# CITY OF SHELBYVILLE

## PLAN COMMISSION

Case Number & Name:	PC 2019-10; Parks and Recreation Maintenance Facility			
Petitioner's Name:	Shelbyville Parks Board			
Owner's Name:	Shelbyville Parks and Recreation			
Petitioner's Representative:	Jenny Meltzer			
Address of Property:	1021 Morris Ave.			
Subject Property Zoning Classification:	Parks and Open Space			
Comprehensive Future Land use:	Parks and Recreation			
	<b>North</b>	<b>East</b>	<b>South</b>	<b>West</b>
Surrounding Properties' Zoning Classifications:	Single Family Residential	Business Highway	Business Highway	Single Family Residential
Surrounding Properties' Comprehensive Future Land Use	Commercial	Conservation	Gateway/Mixed Use	Single Family Residential
History:	The site is the location of Blue River Memorial Park. The Park Board has slowly expanded recreational amenities at this facility and requires a maintenance building to continue to provide a high level of service.			
Vicinity Map:

Action Requested:	Site Development Plan approval for a new maintenance building.

C101

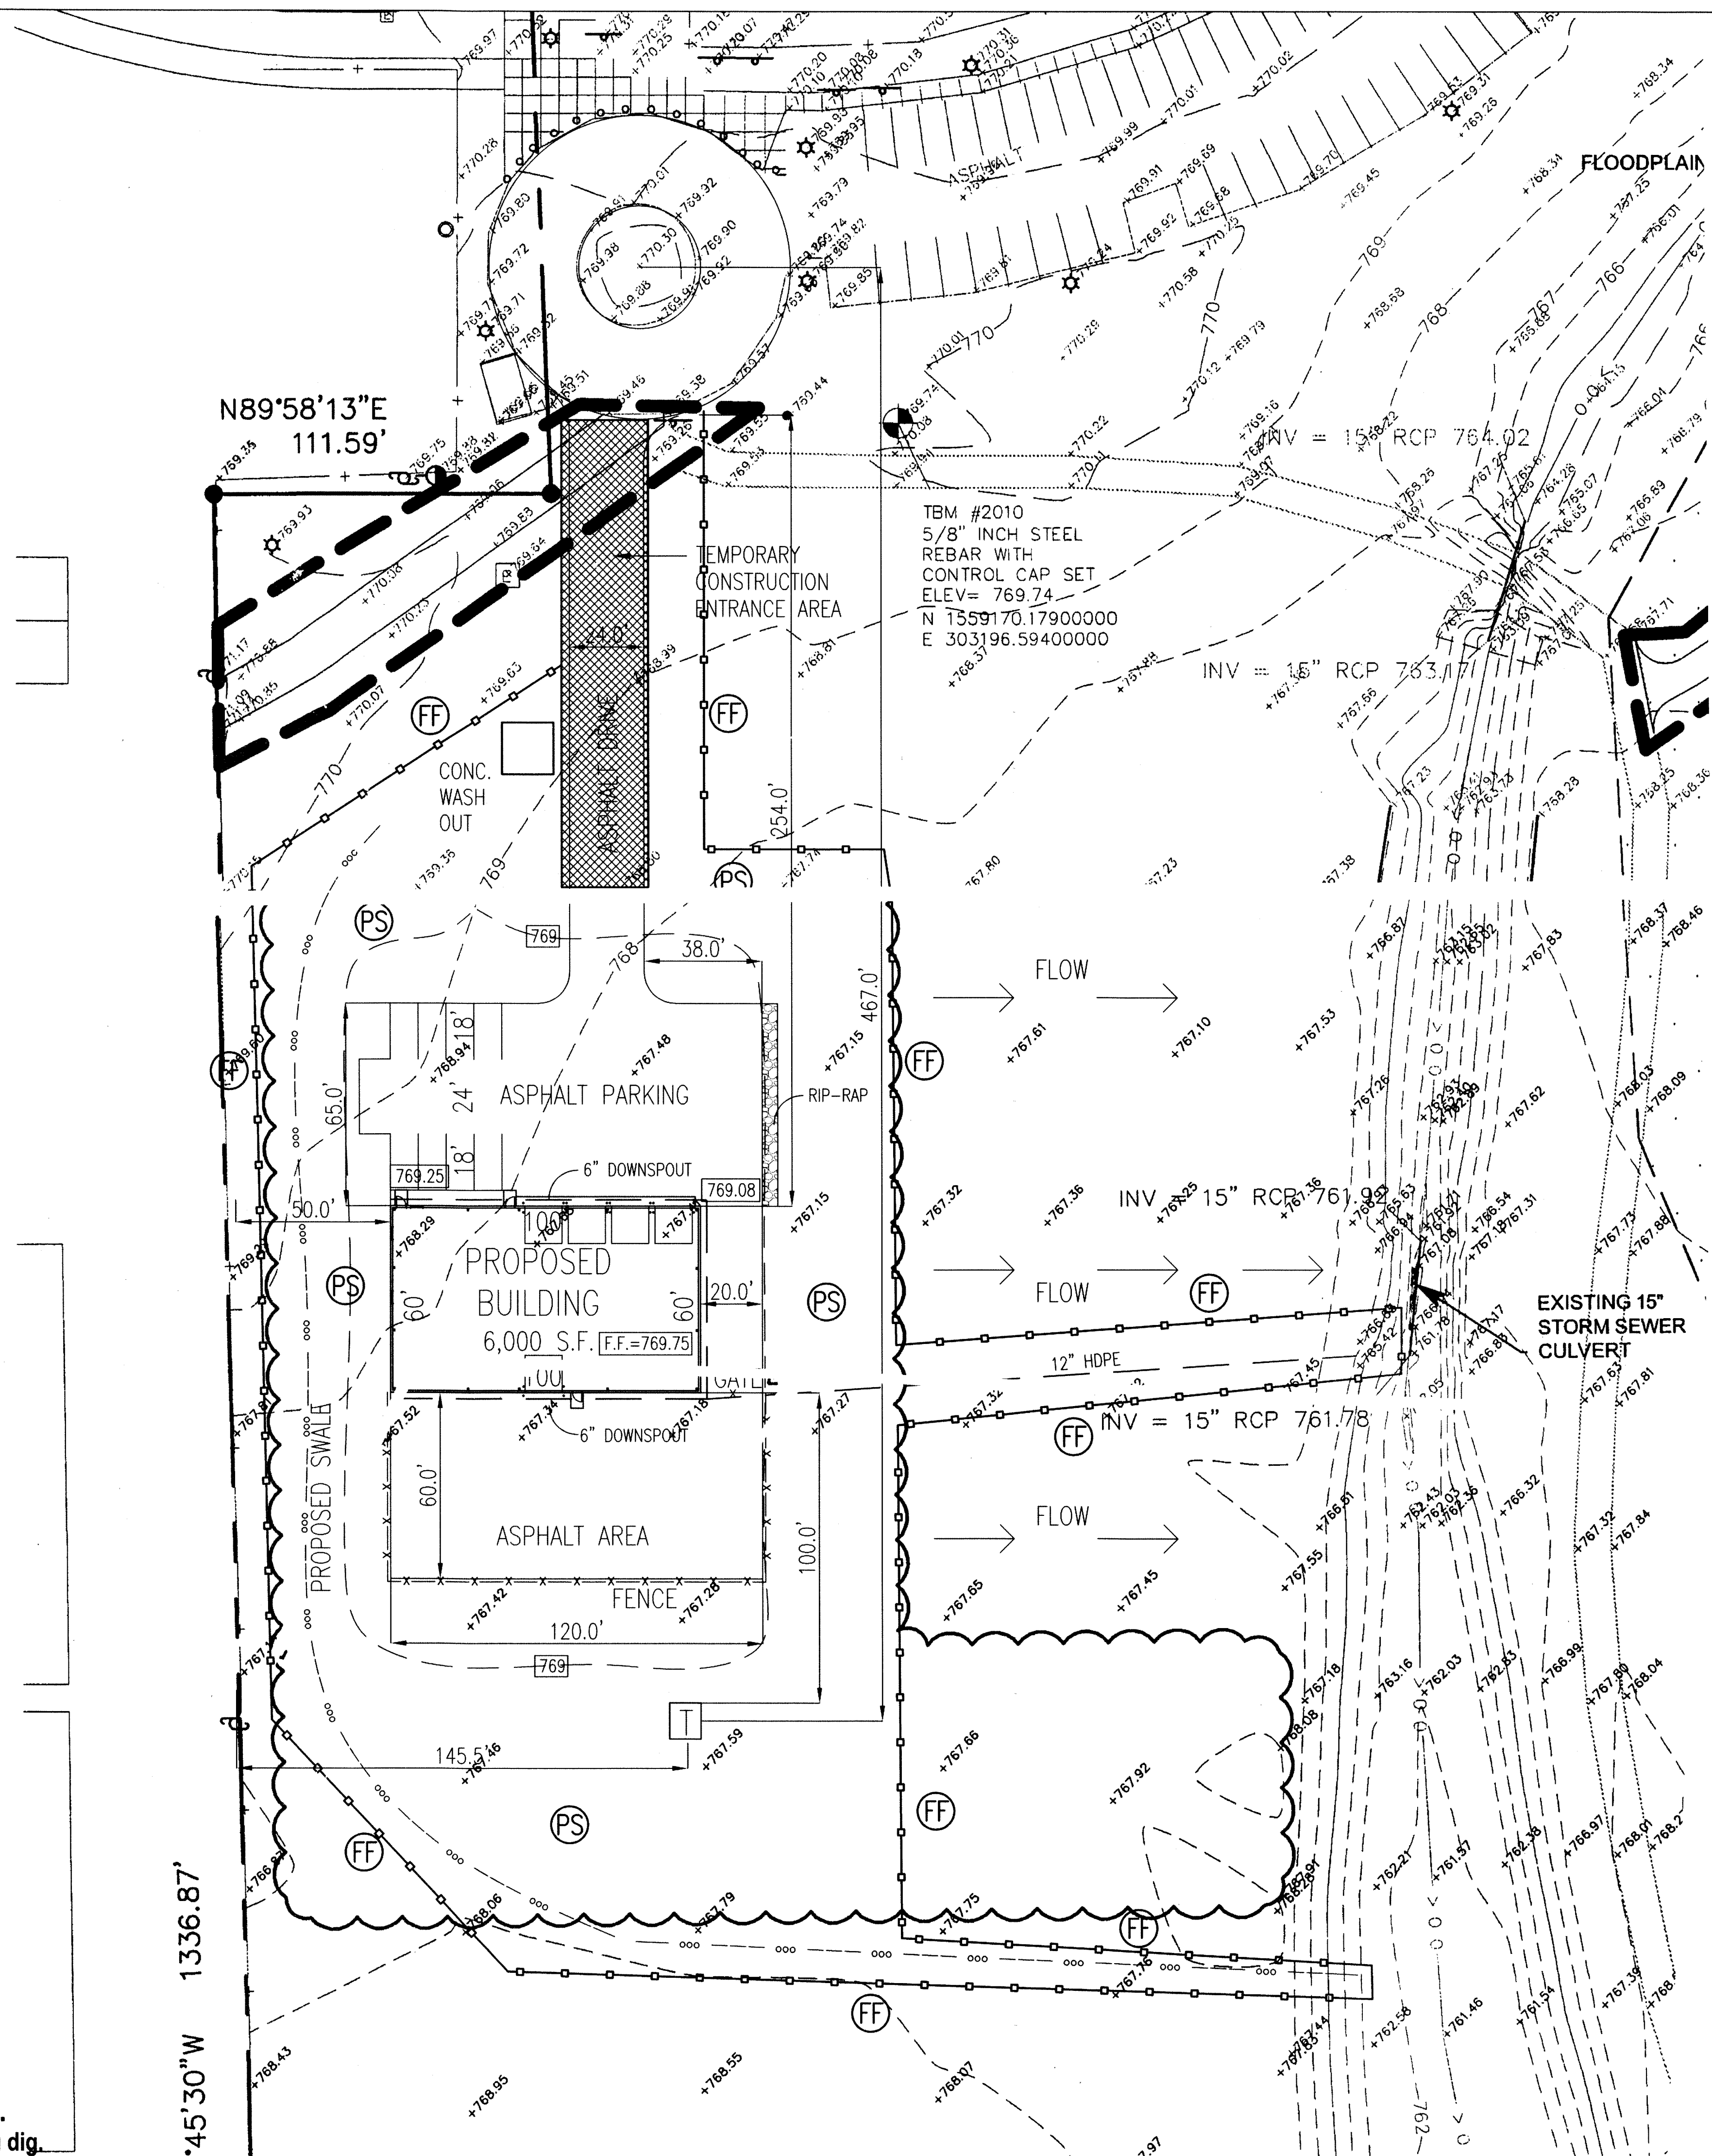
5.20 requires fences, hedges, and walls not to exceed eight (8) feet in height in any side or rear yard and shall not extend past the front facade of the primary structure. There will be a split-face block wall with gates enclosing the outdoor storage area. Drawing C101 indicates

that a six (6) foot high split face block fence with two eight (8) foot wide gates will be installed at the drive entrance on the back of the building.

DATE: JUNE 10, 2019  
PROJECT NO.: 18015  
SHEET NO.  
C104

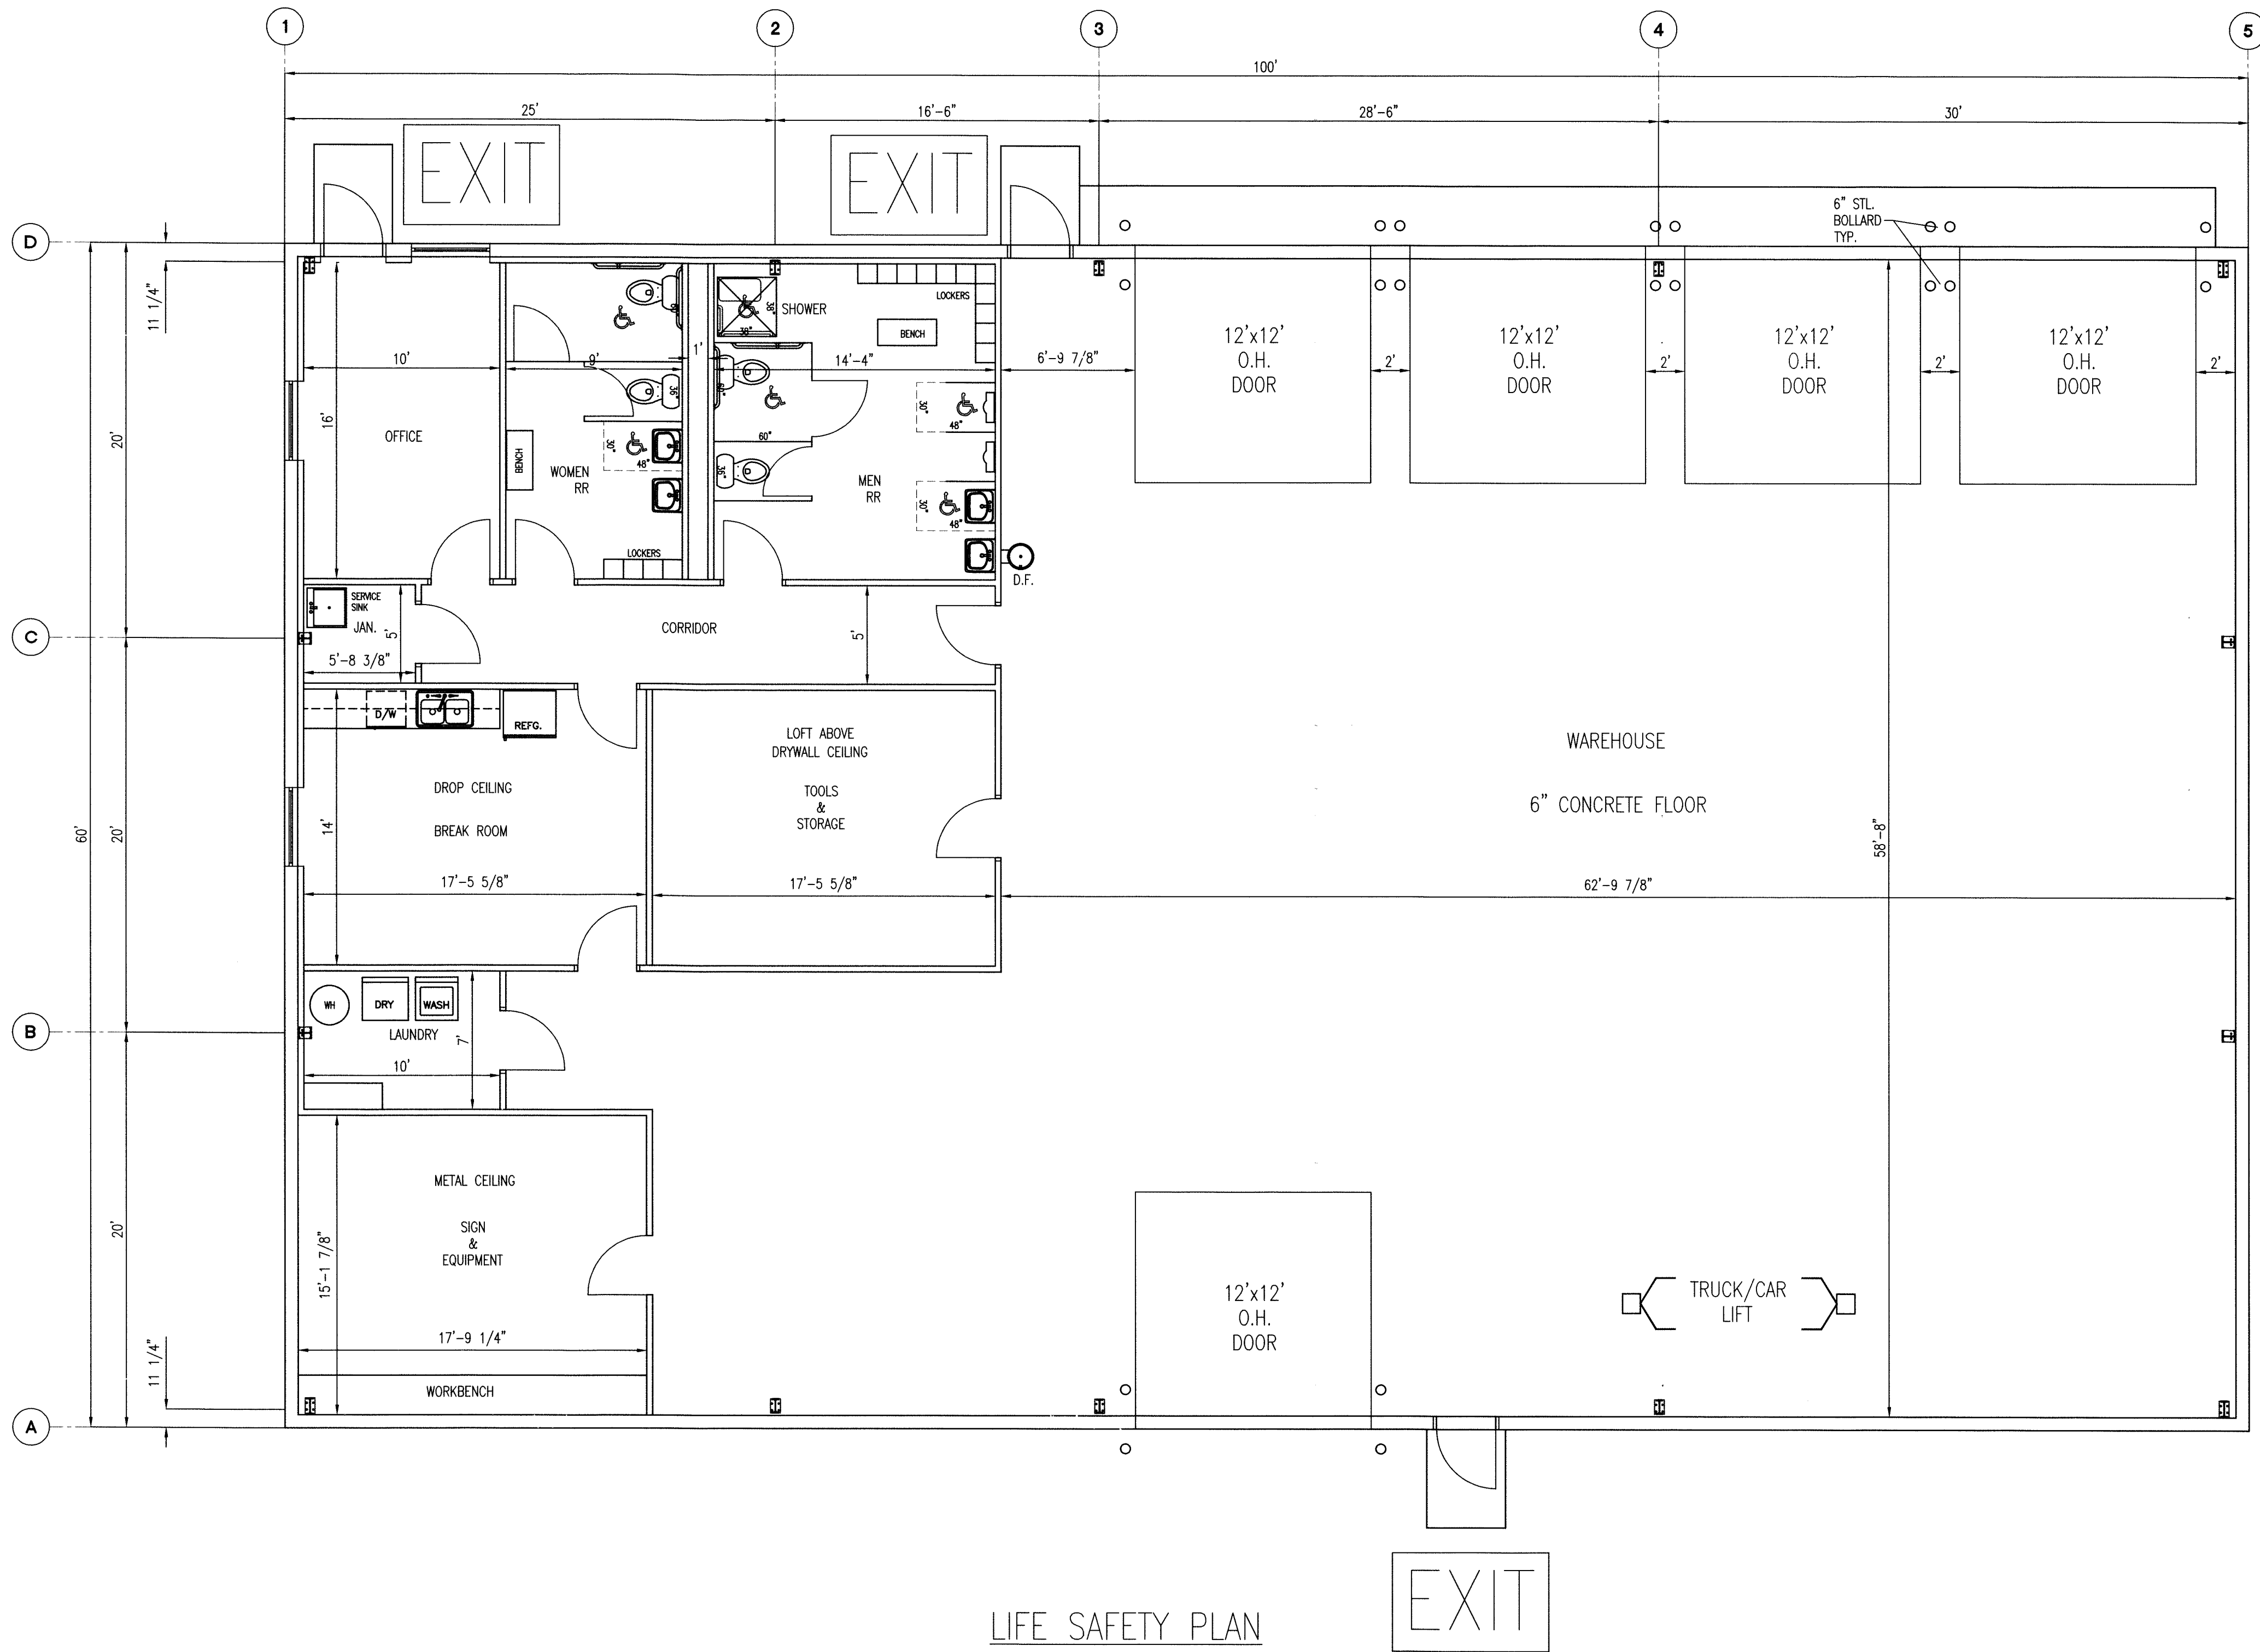
UDO 5.38 requires lighting fixtures on facades to be located, aimed, and shielded so that light is directed only onto the building façade. Drawing C104 indicates the Wall Pak lighting will be places on each of the four (4) facades and shall be 90 degree cut-off fixture directed downward.
